## EXHIBIT 1 - STAFF REPORT

**DATE:** January 5, 2021  
**TO:** Historic Landmark Committee Members  
**FROM:** Chuck Darnell, Senior Planner  
**SUBJECT:** PUBLIC MEETING: HL 4-20 (Certificate of Approval for Alteration) –  
806 SE Davis Street

**Figure 2. Rendering**

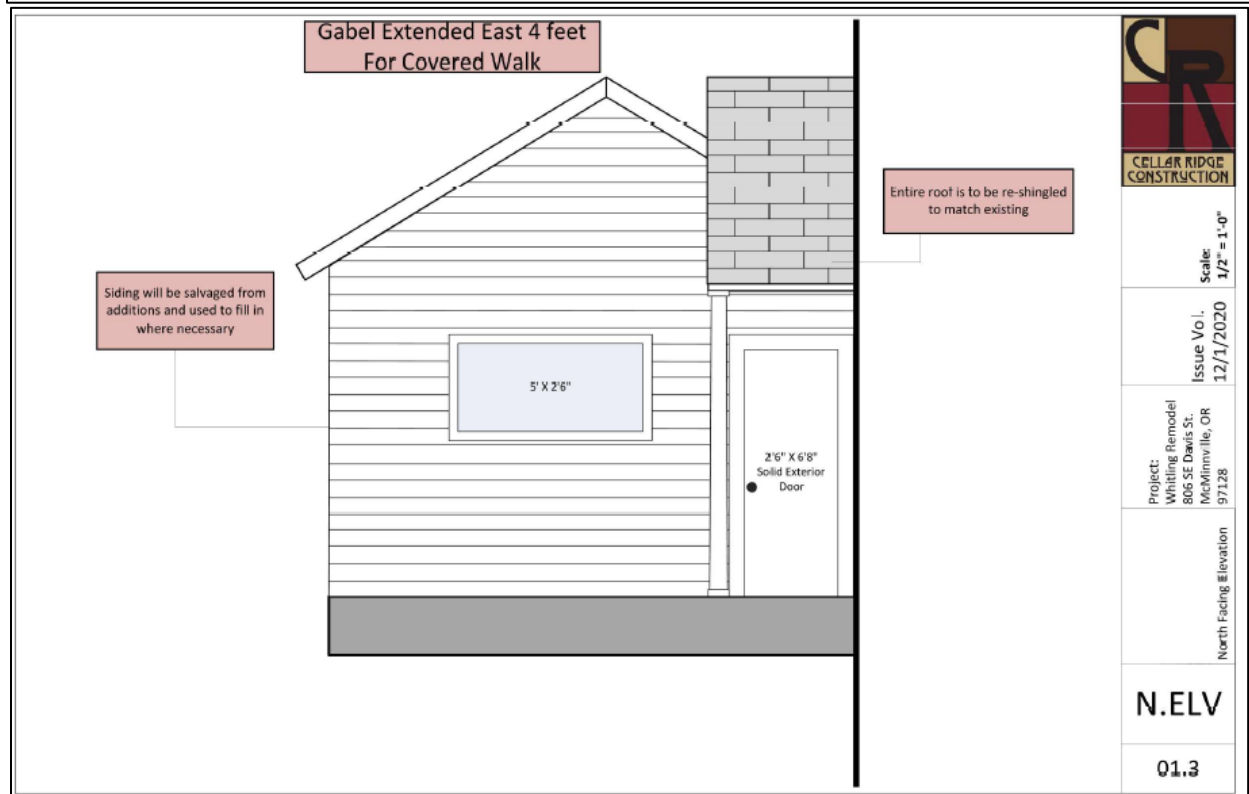
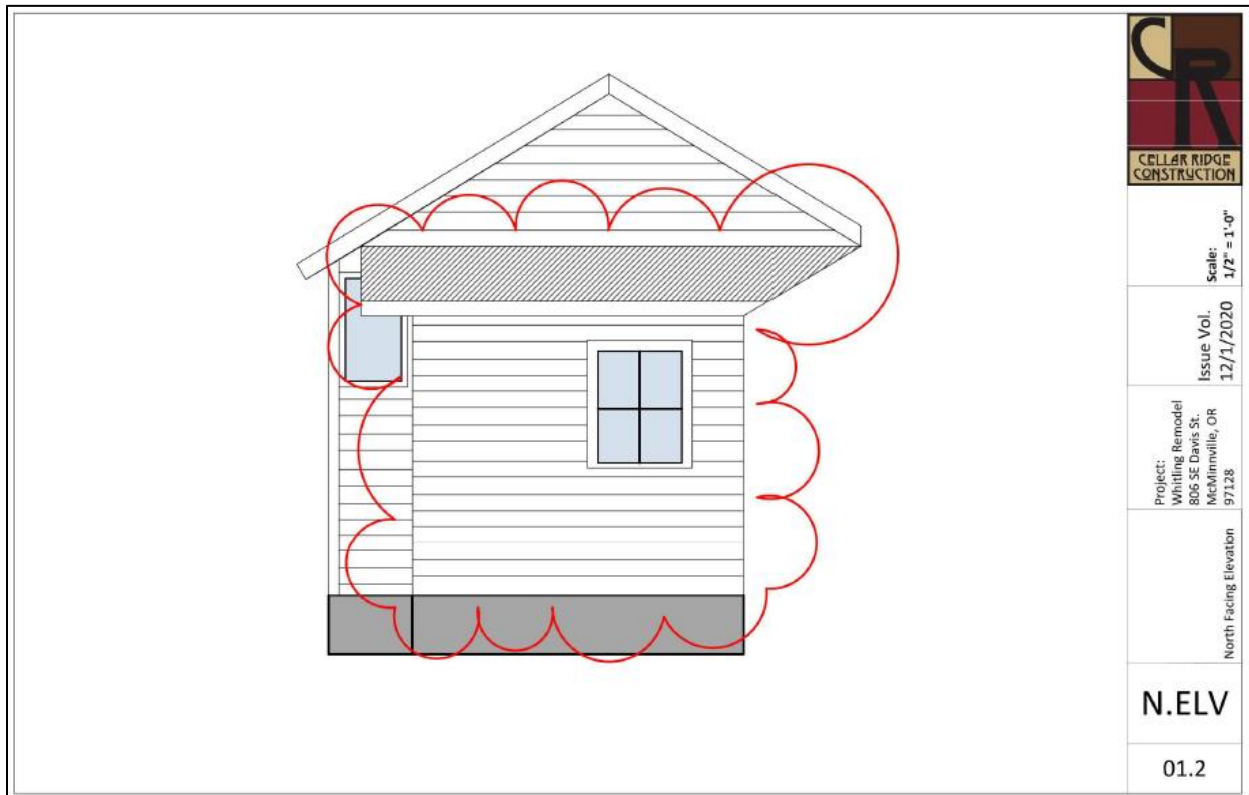
The other alterations, including the removal of the rear additions, extension of the gable roof to create a new rear porch and entrance, and reconfiguration of these exposed rear building facades, are all inter-related. The applicant provided photographic evidence and descriptions of how they believe the existing additions are not original to the structure. Staff also analyzed available Sanborn maps, which reveal that the building footprint was originally more compact and confined to the main home, suggesting that the garage and these additions were added later. Together with the evidence provided by the applicant, staff believes that these porch additions could be removed without resulting in the loss of any significant building feature or space that characterizes the property.

Staff also believes that the alterations to what would then be the exposed and final exterior building facades in this rear area of the building could also be found to be consistent with the applicable historic preservation standards and review criteria. All of these alterations are proposed in areas of the building that are on the rear building facades in locations that are not prominent or highly visible, and are also in an area of the building that is not specifically referenced in the statement of historical significance in the Historic Resources Inventory sheet for the structure. Due to the location of the proposed window, door, and covered patio alterations, and the fact that the alterations would not substantially impact any primary building façade, these proposed alterations generally are not found to detract from the historic character of the historic resource.

The proposed alteration to the roof to allow for the covered porch space will maintain the existing gable form of the roof, extending the gable an additional 4 feet to the east to allow for the covered porch space. Staff believes that this altered roof feature could be found to be compatible because the size and scale of the roof height is not changing, the gable form and width will be maintained, and the scale is not overly dominant of any other prominent historic feature on the building. In addition, the gable end on the new

Figure 3. Elevations

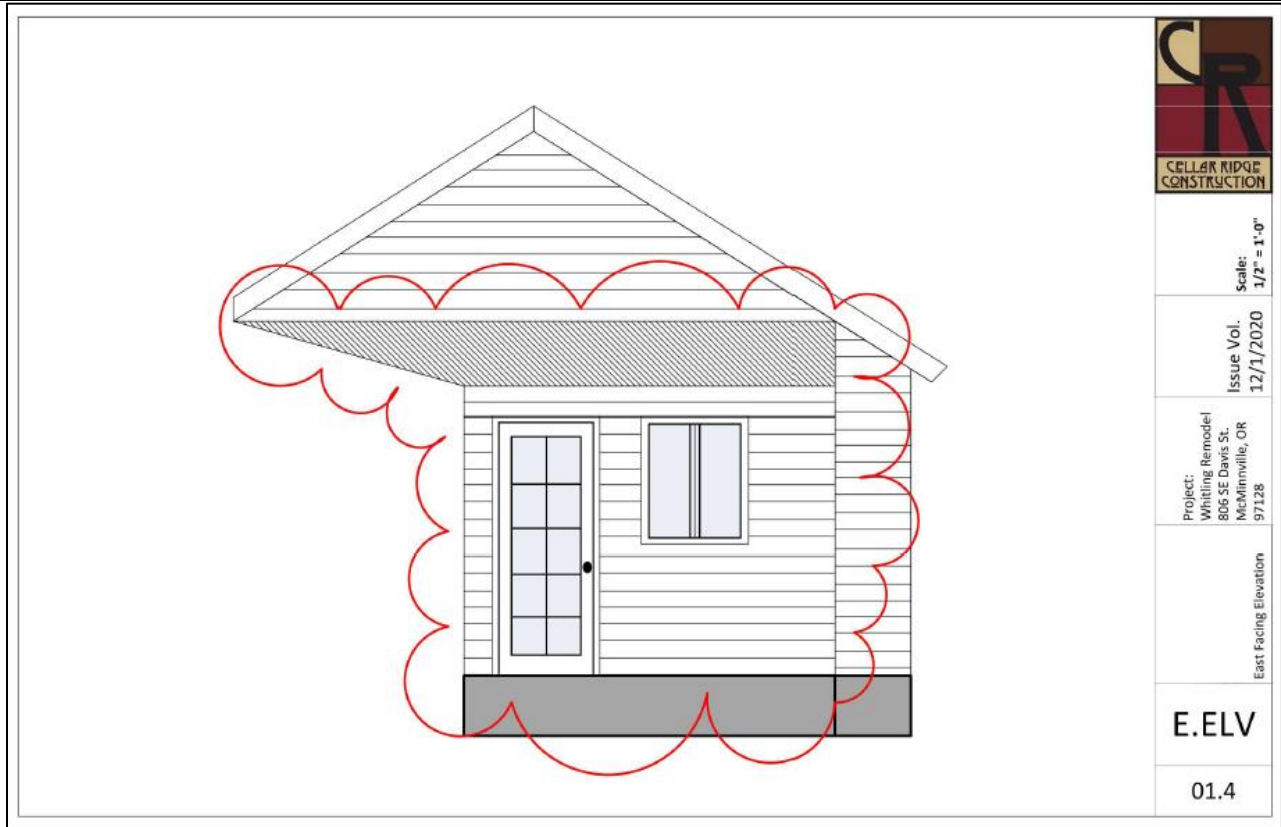
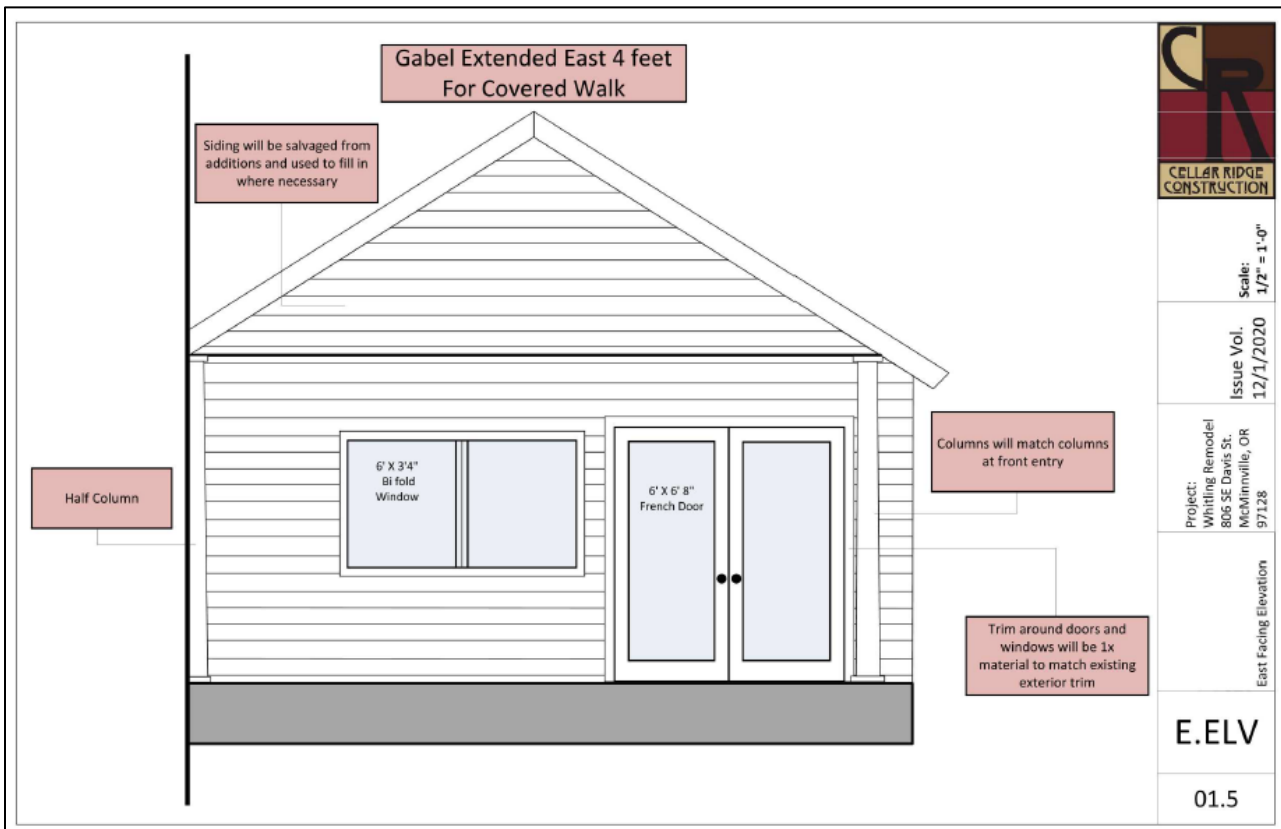
The final exterior of the building, after the removal of the porch additions and extension of the roof feature to create the covered rear porch, is also proposed to be altered. The original east facing façade, as it exists underneath the existing porch addition, will be altered by the relocation of the door and enlargement of the door opening for French doors. The east facing façade will also include a new opening for a new window, and is also proposed to include an extension of the gable roof to allow for a small covered area underneath the extension of the gable roofline. The north facing façade, as it exists underneath the existing porch addition, will be altered by the replacement of the existing door, the removal of one small window, and the addition of a new window more centrally located within this north facing façade. As mentioned above, these alterations are all on the rear building façades, which are not primary façades, are less visible, and do not contain the same type of character defining features that exist on the other primary building facades. Therefore, the relocation and enlargement of the door, as well as the window reconfigurations, could be found to meet applicable historic preservation standards. The window and door fenestration pattern on the rear portions of the building is somewhat irregular, and not as prominent or defined as the fenestration patterns on the front and more visible building facades. The proposed window additions and relocations do not attempt to duplicate any of this historic fenestration pattern on the other building facades, but instead locate windows more centrally in the building walls in a manner that is still compatible with the overall, irregular window fenestration pattern on the rear building facades.

One component of the proposed alterations that staff does not believe is consistent with the applicable historic preservation standards is the proposed materials for the new windows and doors. Staff believes that the materials of the new building components should be consistent with the historic character of the building. The applicant has stated that all other windows on the existing building have been replaced with more modern vinyl windows. However, there are still remaining historic wood materials on the building, including the existing window trim and siding. Wood windows were likely originally on the home and would be more consistent with the remaining historic materials on the building. Therefore, staff is suggesting the inclusion of a condition of approval to require that the new windows and doors be wood to be consistent with the historic materials that existed on the historic resource and to protect the historic character of the historic resource. The condition also states that the windows and doors be finished with trim that matches the remainder of the house, which may be a 1x4 finger jointed pine as proposed by the applicant. The condition does specify that the more decorative exterior window headers that exist on the front building façade do not need to be included in the window and door trim associated with the new windows and doors, since they are on a rear façade and not including that decorative finish will distinguish the new windows and doors from the old.

1. That the new windows and doors be wood to be consistent with the historic materials that existed on the historic resource and to protect the historic character of the historic resource. The windows and doors shall be finished with wood trim that matches the size and dimension of the existing window trim on the remainder of the house. The more decorative exterior window headers that exist on the front building façade do not need to be included in the window and door trim associated with the new windows and doors.

2. That the siding on all final exterior building facades be a wood, horizontal siding that is consistent with the siding on the remainder of the home. As stated in the application narrative, the applicant shall attempt to save any matching siding from the porch additions being removed to be used in the final exterior building facades.
